[Docket No. 96-CE-09-AD; Amendment 39-9872; AD 97-01-01]

Airworthiness Directives; The New Piper Aircraft, Inc. PA24, PA28R, PA30, PA32R, PA34, and PA39 Series Airplanes

ACTION: Final rule.

**Figure 1**

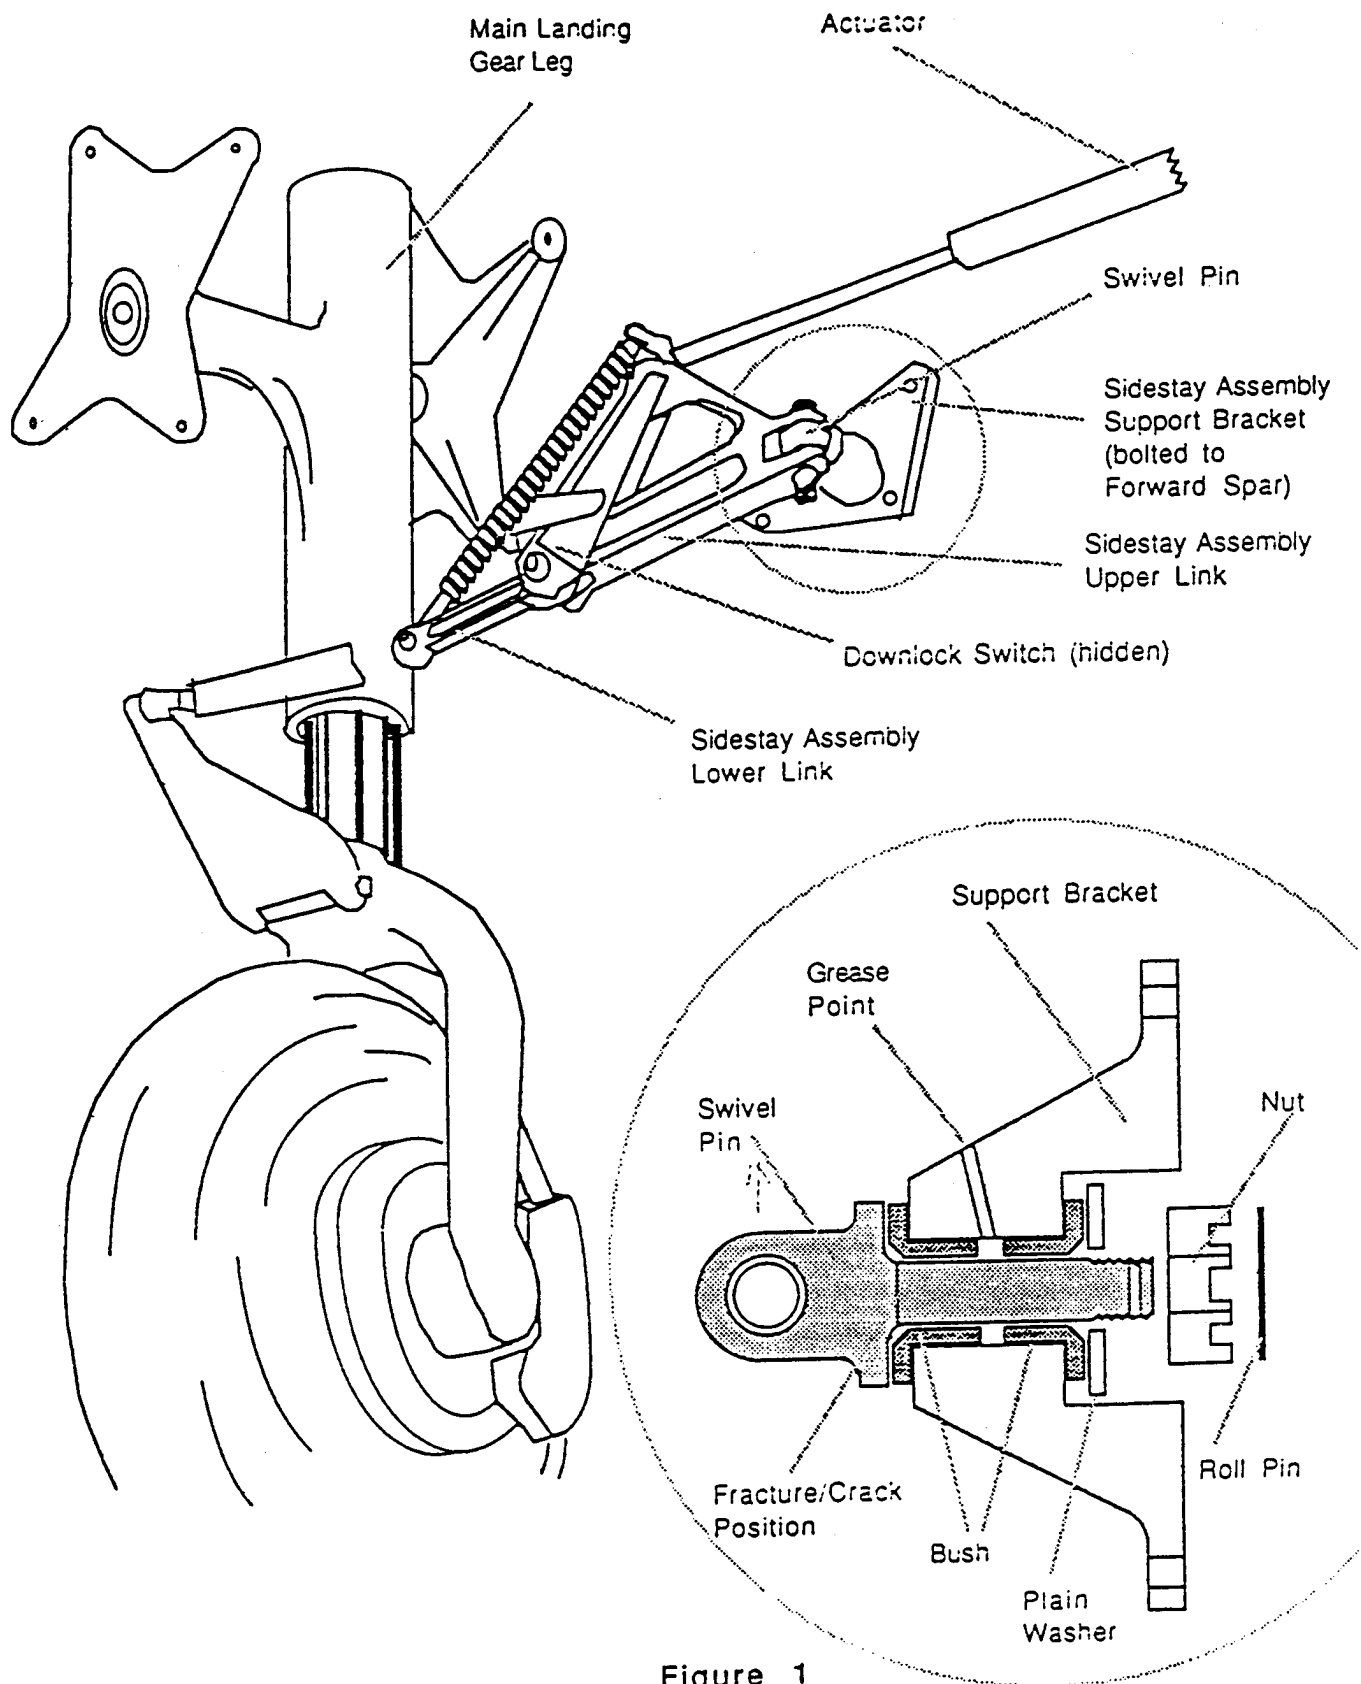
Webco recommends that the FAA add cautionary information to the AD on reaming and chamfering the existing two-piece bushings, P/N 67026-6, on the Piper PA-28R, PA-32R, and PA-34 series airplanes. Webco states that the manufacturing and service limits for the P/N 67026-6 bushings are so close that reaming could induce gouges that are deeper than the minimum dimension specified by The New Piper Aircraft, Inc. Webco also recommends that the FAA incorporate specific guidance into the AD, emphasizing that only the head side of the bushing requires chamfering to accommodate the radius in the shank of the sidebrace stud.

The FAA concurs that additional guidance on chamfering the bushing would be helpful and has reworded the AD to incorporate the commenter's specific recommendation.

The FAA does not concur that more guidance is needed on reaming the bushings. The proposal specifies reaming the inside diameter of the bushings to a dimension of .624-inch to .625-inch. If the bushing is reamed to a dimension other than that specified in the AD, then compliance with the AD would not be accomplished.

(iii) For the affected Models PA28R-180, PA28R-200, PA28R-201, PA28R-201T, PA32R-300, PA34-200, and PA34-200T airplanes, ream the existing two-piece bushings, P/N 67026-6, to an inside diameter of .624-inch to .625-inch, chamfer the head side of the bushing to accommodate the radius in the shank of the main gear sidebrace stud, and install the 5/8-inch stud, P/N 78717-02. No repetitive inspections will be required by this AD when this action is accomplished. If the bushings cannot be reamed while installed in the bracket (i.e., the bushings are loose), then install a main gear sidebrace bracket assembly, P/N 95643-06, P/N 95643-07, P/N 95643-08, or P/N

(2) Ream the existing two-piece bushings, P/N 67026-6, to an inside diameter of .624-inch to .625-inch, chamfer the head side of the bushing to accommodate the radius in the shank of the main gear sidebrace stud, and install the 5/8-inch stud, P/N 78717-02. If the bushings cannot be reamed while installed in the bracket (i.e., the bushings are loose), then install a main gear sidebrace bracket assembly, P/N 95643-06, P/N 95643-07, P/N 95643-08, or P/N 95643-09, as applicable.
